Office Action Summary	Application No. 10/501,034	Applicant(s) HUPERZ, ULRICH	
	Examiner Eric Culbreth	Art Unit 3616

DETAILED ACTION

Fig. 1

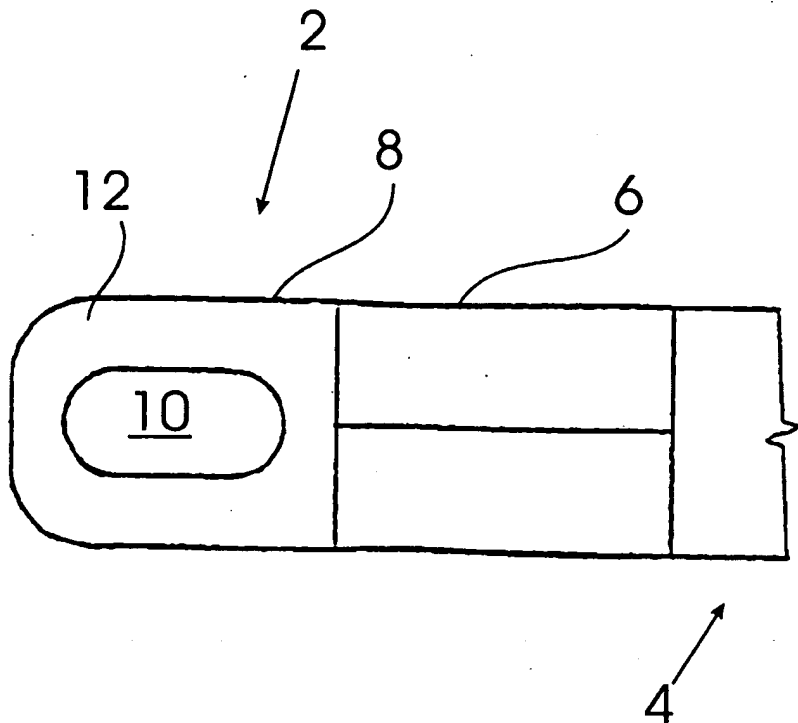
1. The drawings were received on 1/29/07. These drawings are not approved.
 - a. Figure 3 should be labeled "New Sheet" as it is a new drawing, not a replacement sheet.

- c. There is no support in the original drawings for the shape now shown for layer or band 14, and the lead line for 14 was to a different part in the original Figure 2.

- d. Figure 3 is new matter (there is no support from the original disclosure for the zigzagging pattern now illustrated being the mechanically interlaced limitation claimed). Also, even the showing of "interlacing" in new Figure 3 is not really interlacing (interlacing by dictionary definition is "to intertwine", "to cross one another as if woven together" and "to pass alternately over and under" (The Random House College Dictionary, revised edition © 1980); hence, the drawing still does not show interlacing as claimed).

*Not
approved
EC
4/4/07*

3. To correct the drawings at this point, it is recommended that the 1/29/07 drawings be resubmitted with Figures 1 and 2 each labeled "Replacement sheet" and with new Figure 3 labeled "New Sheet". Also, in the next correspondence, a Brief Description of Figure 3 should be added in which it is stated that Figure 3 is a "schematic" or "diagrammic" representation of interlacing (meaning only a symbolic representation) and that a description of Figure 3 be added to the detailed description of the invention. And the specification should be amended to recite that the showing of the band or layer 14 in Figure 2 is a "schematic" or "diagrammic" illustration.
